REQUEST

Current Zoning: R-4 (single family residential)
Proposed Zoning: UR-2(CD) (urban residential, conditional)

Approximately 0.472 acres located along the south side of Rutgers Avenue, the east side of Ligustrum Street, and west of Sugar Creek Road.

The petition proposes redevelopment of the site to allow a new duplex and the retention of an existing duplex with a density of 8.4 dwelling units per acre.

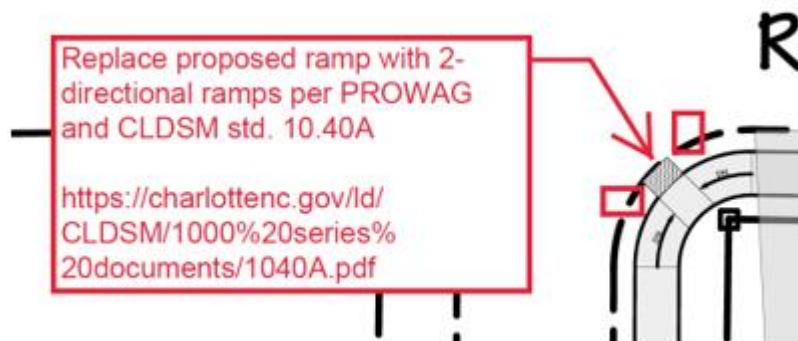
- The site is located adjacent to Rutgers Avenue (City-maintained, local street) and Ligustrum Street (City-maintained, local street). Site plan revisions are needed to meet ordinance requirements and the outstanding items including, but not limited to providing an 8-foot minimum planting strip along Rutgers Avenue and Ligustrum Street and providing two accessible ramps at the intersection of Rutgers Avenue and Ligustrum Street to meet accessibility requirements.
- **Active Projects:**
 - There are no active projects in the immediate area.
- **Transportation Considerations**
 - See Outstanding Issues, Notes 1-4. Addressed
- **Vehicle Trip Generation:**
 - Current Zoning:
 - Existing Use: 15 trips per day (based on 1 duplex).
 - Entitlement: 15 trips per day (based on 1 duplex).
 - Proposed Zoning: 30 trips per day (based on 2 duplexes).

1. ~~Revise site plan and conditional note(s) to commit to construct an 8-foot planting strip, on Rutgers Avenue and Ligustrum Street, per Chapter 19 of the City Code and required within Chapter 9 of the Zoning Ordinance. Addressed~~

2. ~~Add site plan note(s) specifying dedication and fee simple conveyance of all rights-of-way to the City before the site's first building certificate of occupancy is issued. CDOT requests rights-of-way set at 2 feet behind back of sidewalk where feasible. Addressed~~

3. ~~Add site plan note specifying that all transportation improvements will be approved and constructed before the site's first building certificate of occupancy is issued. The petitioner may phase transportation improvements if said improvements and phasing are explicitly described in site plan notes. Addressed~~

4. ~~Revise site plan and conditional note(s) to commit to providing two accessible ramps at the intersection corner of Rutgers Avenue and Ligustrum Street. Addressed~~

5. ~~Add note that site must comply with the City of Charlotte tree Ordinance. Addressed~~
